THE CITY OF DURHAM TRUST

DM/25/00762/FPA – Land at Red Barns, Brandon, Durham DH7 8DA

Hybrid application comprising full planning permission for the construction of 140 dwellings, primary site access and associated SuDS and landscaping; and outline planning permission with all matters reserved for the construction of up to 260 dwellings, secondary access, local centre incorporating retail (up to 4,000 sqft) (Use Class E) and mini-mobility hub, and associated SuDS and landscaping.

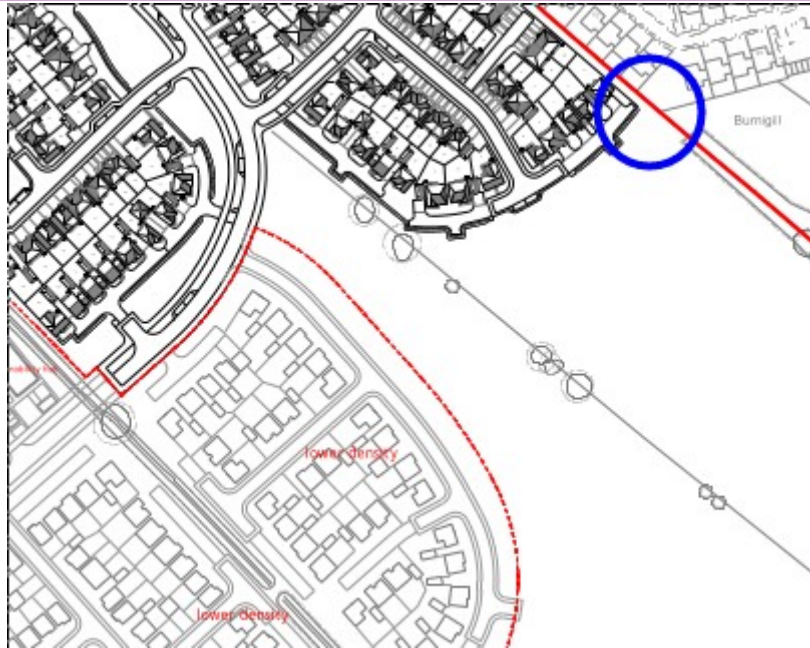
1. providing a signalised crossing of the A690 and footway connecting to Sawmill Lane to access the site
2. relocating and upgrading bus stops adjacent to the site, and widening the access footway
3. improving the railway path crossings of Sawmill Lane and Carr Avenue.

Items 1 and 2 are surely the bare minimum that one might expect to provide safe access to the site. The railway path crossing improvements are stated to consist of tactile paving, dropped kerbs and coloured surfacing. There are, in fact, already dropped kerbs and coloured surfacing (a bit worn) in both locations, so this improvement is minor.

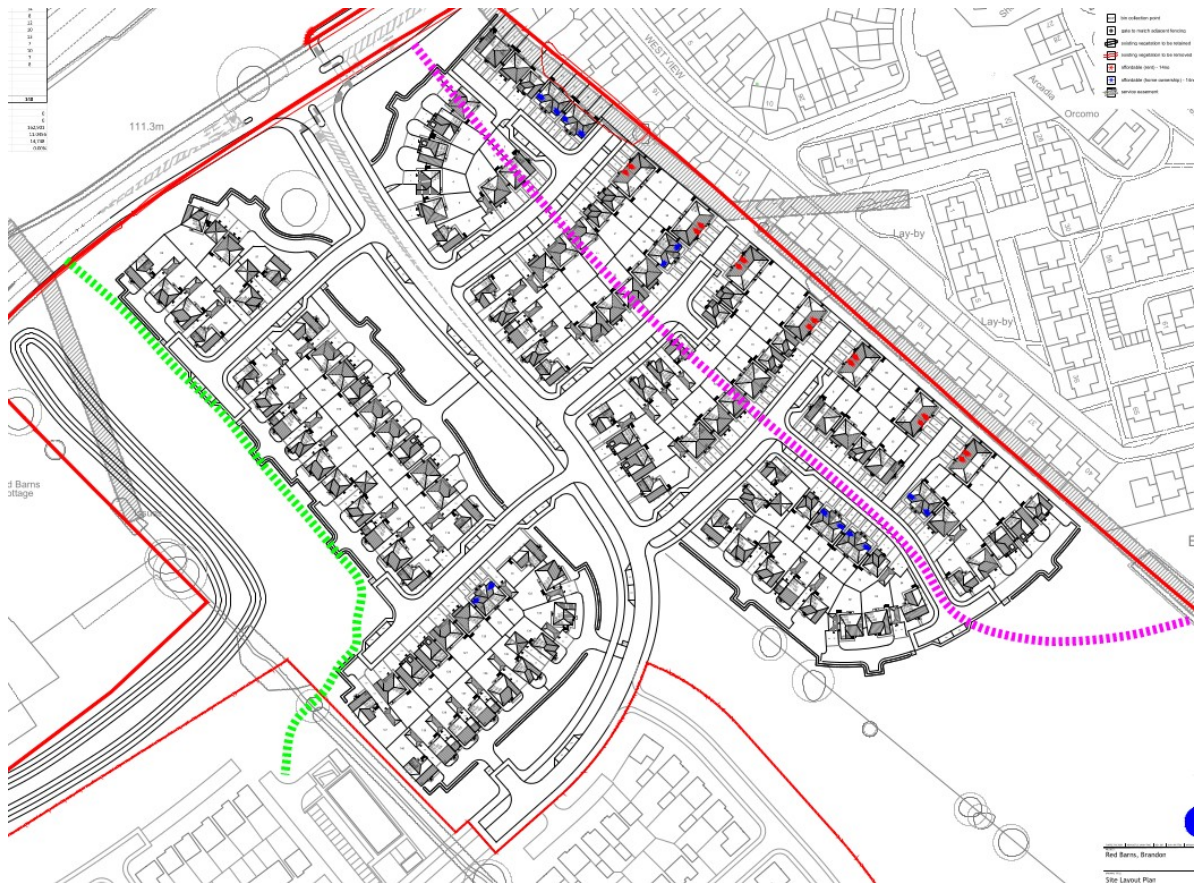
Near to the A690 access, on the south side of the main access road, the applicant proposes a group of 3-bed detached properties, set in green space. It is possible that these are intended to command a premium sale value. The properties are divided into three groups, with car access from the north-west of the block, the middle, and the south-east. It is unclear whether foot access will be continuous across all three blocks, as the common access driveways are shown

as divided. Presenting their car parking at the front of the property, the property design clearly prioritises car access over sustainable modes.

The layout also limits social interaction because the main pedestrian and cycle access along the street is far from the front doors. This runs counter to NPPF para. 96(a) which speaks of achieving inclusive spaces which

Depending on the intended market, the layout may discourage interaction between the wealthiest members of the community and the less well-off, causing social division. This conflicts with the Building for Life SPD item 4c which asks “are the different types and tenures spatially integrated to create a cohesive community?”. The applicant's response to this question only relates to affordable housing, the distribution of which is criticised by the DCC Housing Officer.

We have already noted above the fact that the proposed main access road is likely to encourage speeds of more than 20mph because the housing is set back substantially on one side. There are also no pedestrian or cycling routes through the development other than alongside the roads. The green space could be repositioned, to include a new green walking and cycling route intersecting (and taking priority over) all the side roads to the east, and extending to make a connection to footpath 102. Housing could be reoriented to front onto this new path to provide natural surveillance. The consequent narrowing of the main road alignment would help to keep traffic to lower speeds, and bringing the main access road close to the housing to the south-west of the road would promote social interaction, dealing with this issue noted above.

The applicant could also add a continuous foot/cycleway to the west of the first phase of housing, leading to the local centre, created by providing a path alongside the shared driveways on that side. Such a network would be a far more convincing response to the vision set out in
